Avolites LTD Engineering Change Notice

ECN title	Sapphire motor fader belt repair		
ECN Number	ECN-0211		
Related Product(s)	All Sapphire Touch console up to ST-0274 All Sapphire fader wings up to STFW-020		
Date / Author	09/05/2015	JB Toby	
Reasons for ECN	Weak clamping of the belt allows for the belt to slip and damage to the belt		
Parts required	RTV Silicone Adhesives, see below for specification Small cable tie to apply adhesive		
Tools required	Tools to remove fader PCB.		
Estimated time	15 Minutes per board once removed from the console A whole console takes up to 3 hours excluding curing time. (PCB remove, inspect and modify faders, PCB replace, test console.

Non suitable adhesive:

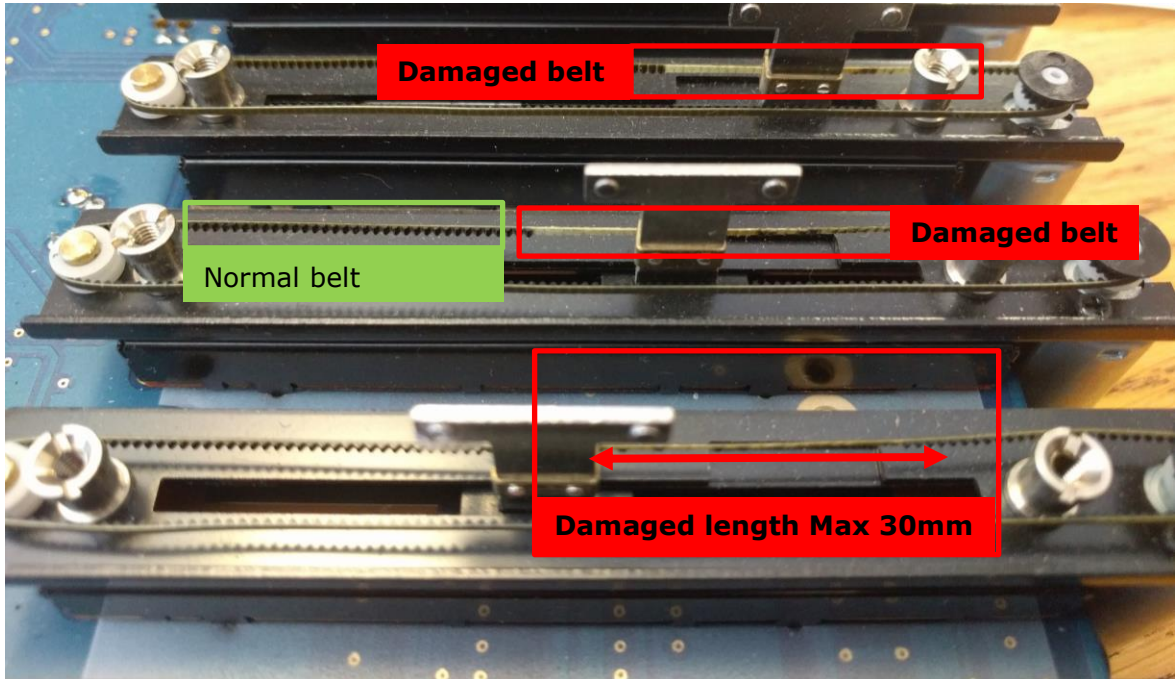
Hot glue is **NOT** suitable due to its rigidity.

Do **NOT** use **ANY** solvent based contact adhesive like contact adhesive as these attack the belt.

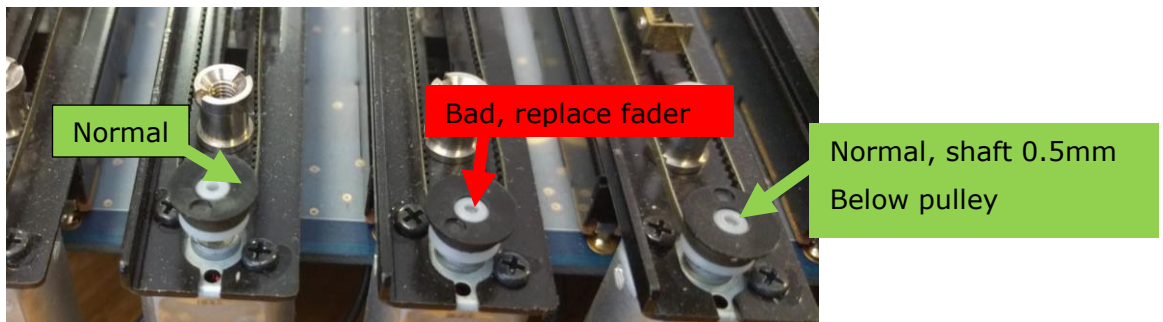
Check that the belt wear is not too long, the maximum damaged belt length is 30mm

2. If the belt is damaged over a length longer than 30mm replace the fader, (See image above)
3. Check that the motor pulleys is not raised more than 1mm above the, normally the shaft is about 0.5mm under the head of the pulley

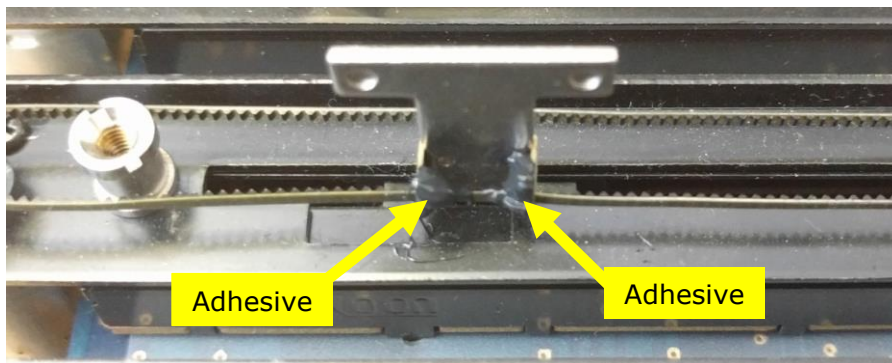
5. Now that all faders have past the initial test, apply the adhesive to all faders as described below;
- A. If the belt has been stripped, place the fader shaft in the centre of the stripped area as shown below

- B. Apply two small dabs (see below for sample size) of adhesive on the **inside** of the fader shaft clamp, make sure to work the adhesive onto the belt as well as the clamp.

Sample size of amount of adhesive, circa 3mm sphere.
